35/13-98K 5804 Cedar Parkway
(Chevy Chase Village Historic District)

HISTORIC PRESERVATION COMMISSION STAFF REPORT

Case Number: 35/13-98K

PROPOSAL: Rear and Side addition, new terrace

B REAR ELEVATION
 SCALE 1/8" = 1'-0"

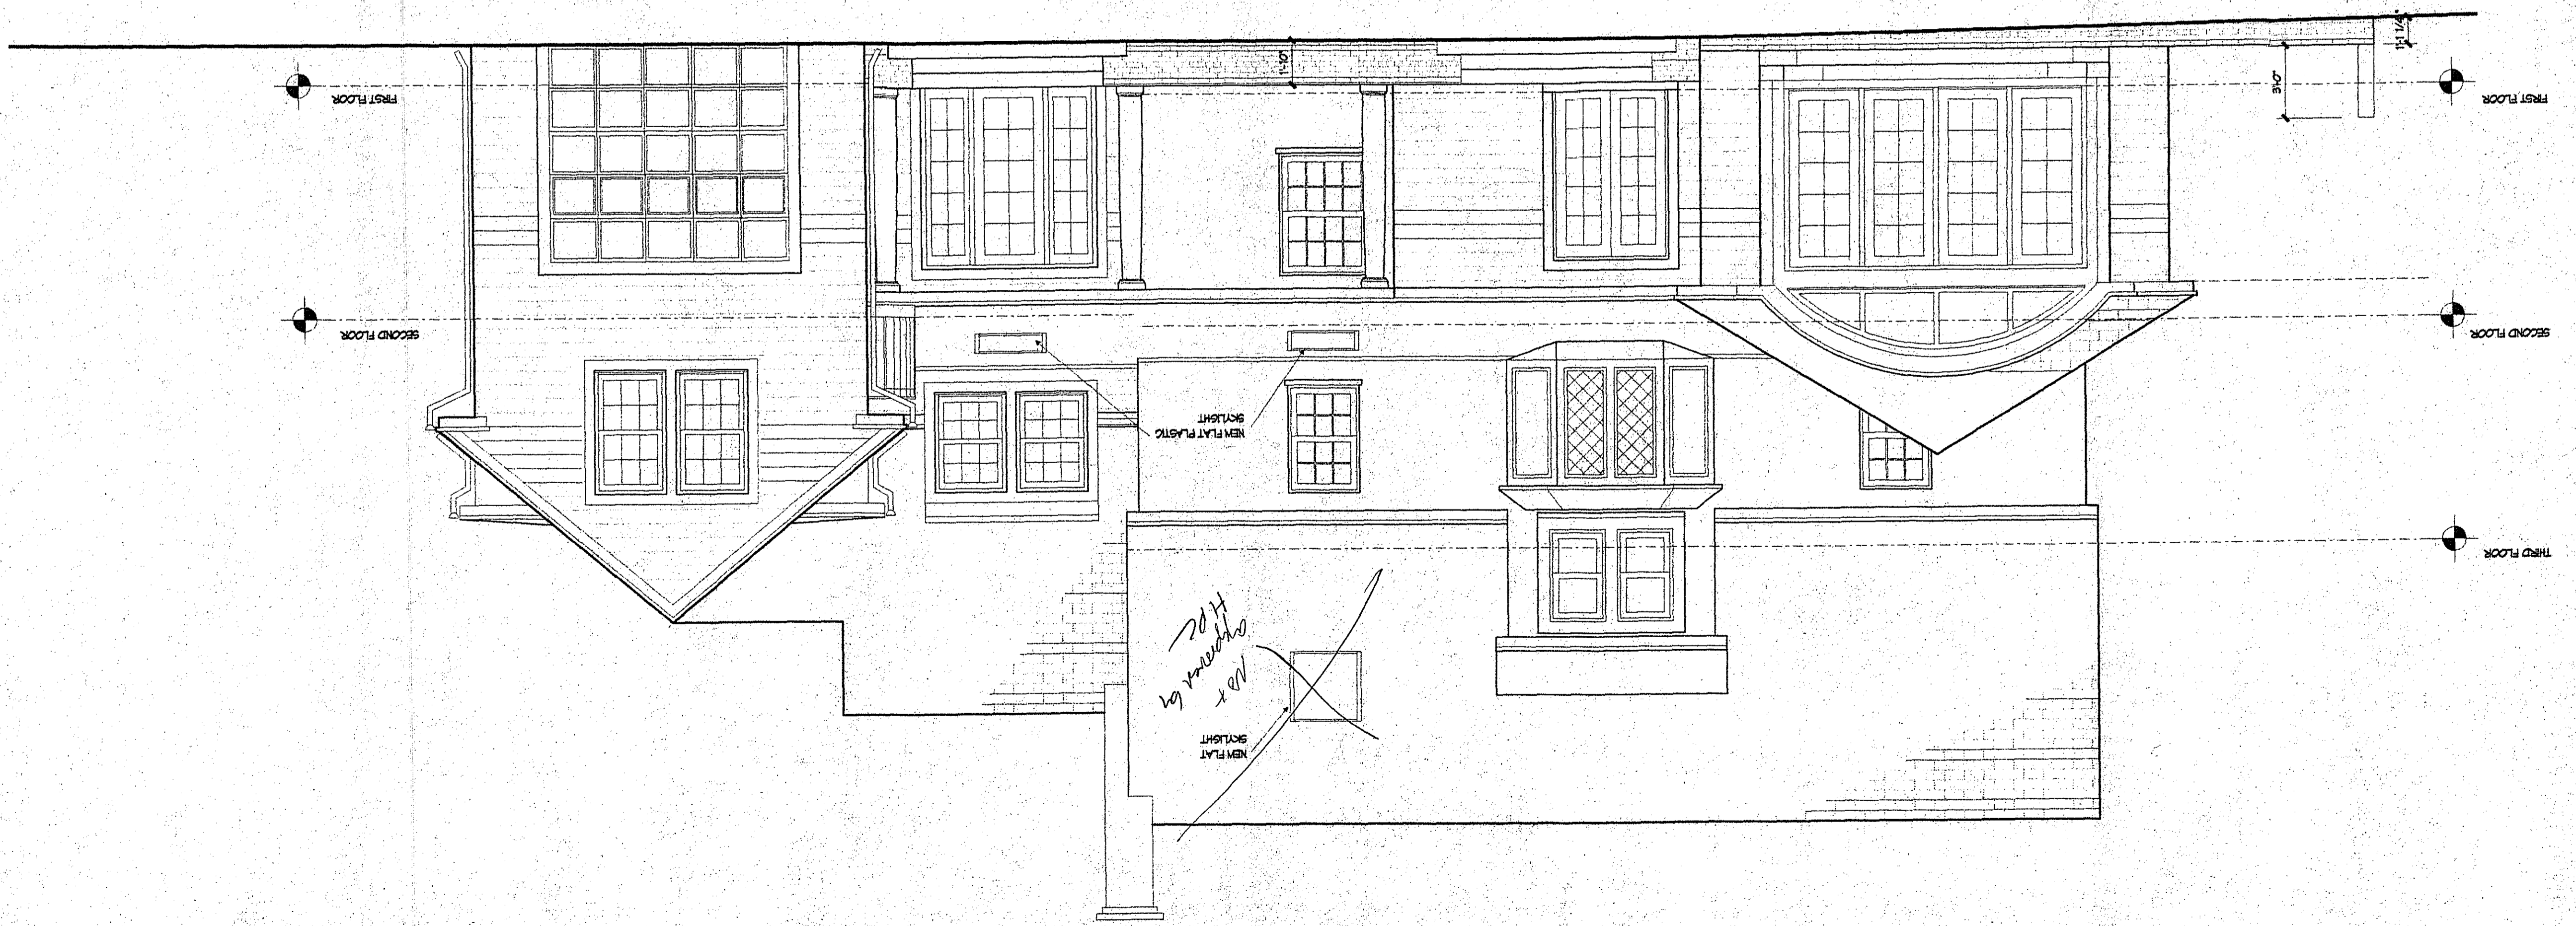
Thank you for contacting the Historic Preservation Commission (HPC) with your proposed revision to the approved Historic Area Work Permit (HAWP) at the Knopes residence. The Commission reviewed the proposal to add a skylight on the rear roof, as per the drawing submitted by you with your letter dated September 16, 1998.

Please be advised that we would like to add a skylight to our HAWP for the Knopes residence, located at 5804 Cedar Parkway in Chevy Chase. Enclosed you will find photos of the site taken from Hasketh Street as well as the elevations showing the location of the skylight. The photos show that the roof on the rear of the house is obscured for the most part by trees and shrubs that will remain on the property. In addition, the height of the house and the angle that the house sits in relation to Hasketh Street will make it difficult to see the proposed skylight. The skylight dimensions will be approximately 2' x 4' and will be as flush to the roof as possible. It will be flashed with copper to match the existing flashing on the house.

The HPC approved the proposed revision, and the stamped concept drawings are included with this letter for your use. **This letter serves as confirmation of HPC approval for the revision to your HAWP in HPC Case No. 35/13-98K.**

PROPOSED SITE PLAN

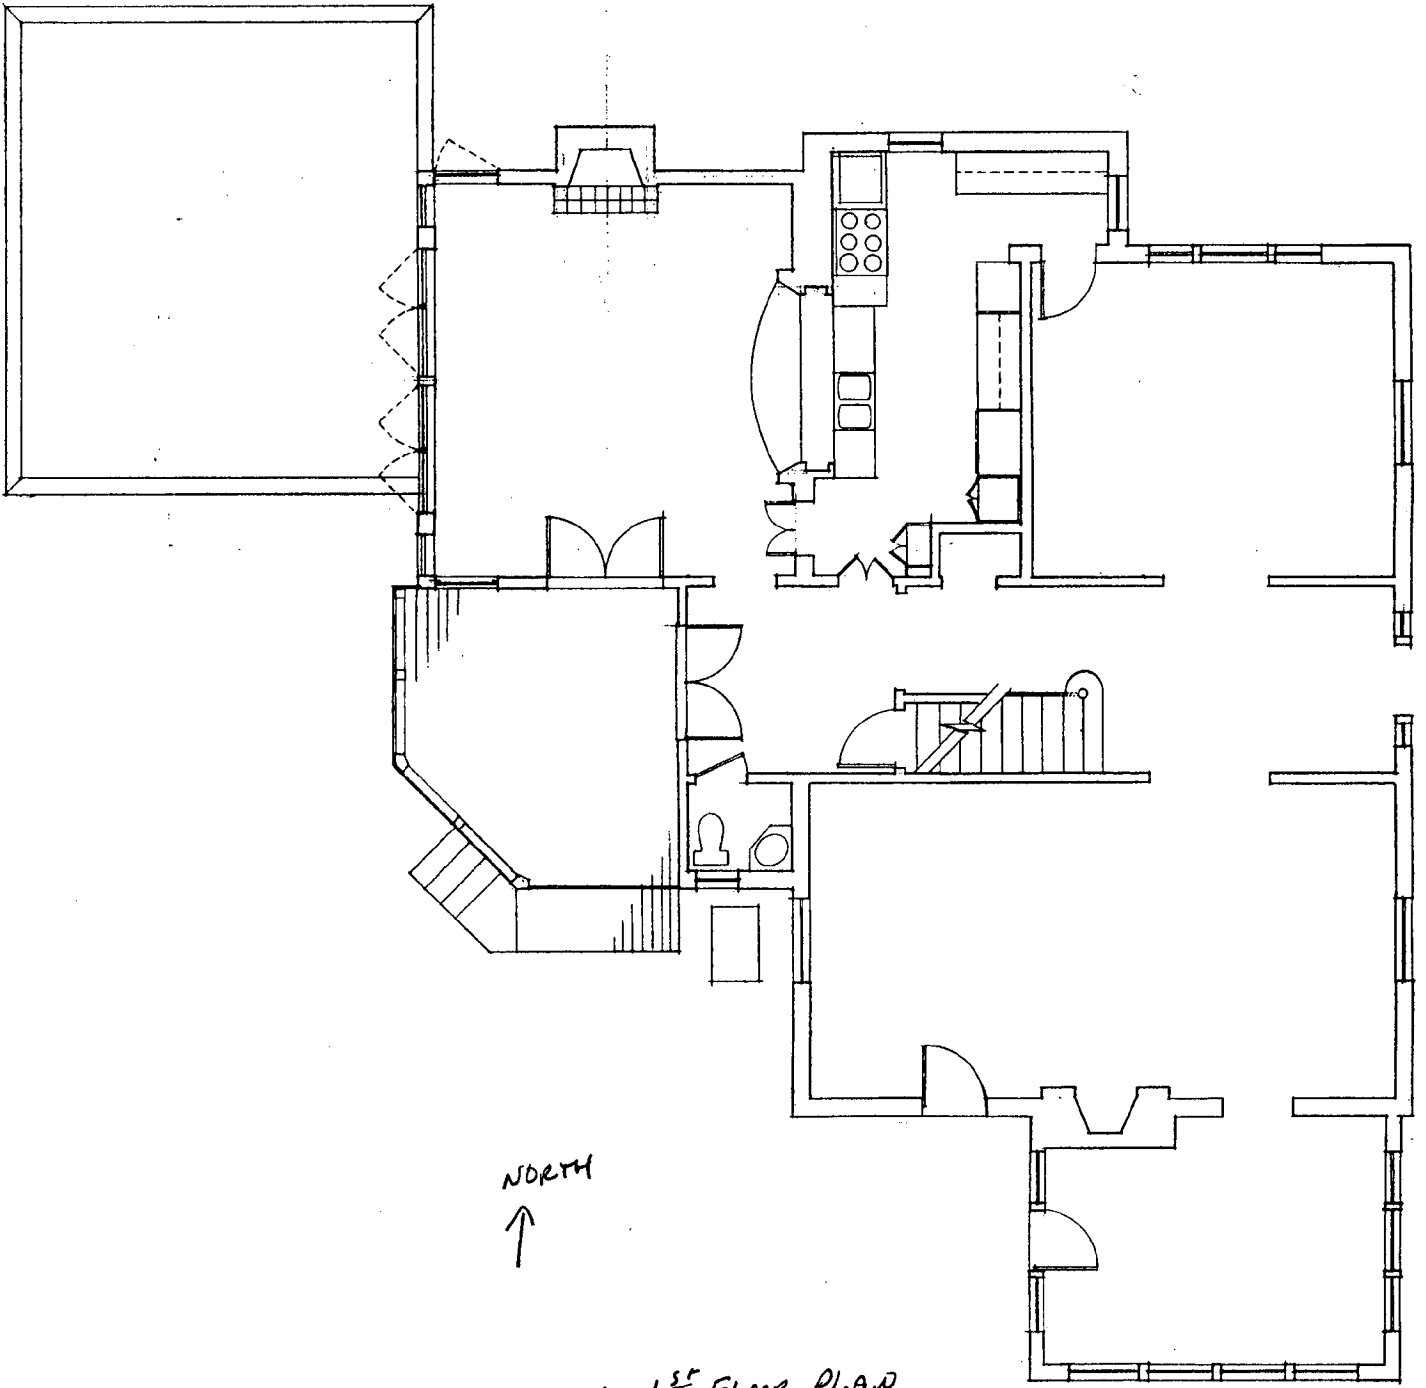
The large hedgerow along Hesketh Street will remain in place, as will the large tree in the rear which will be adjacent to the new terrace. Some of the existing driveway paving will be removed, and the new parking area will be reconfigured closer to the street (see Circle 8).
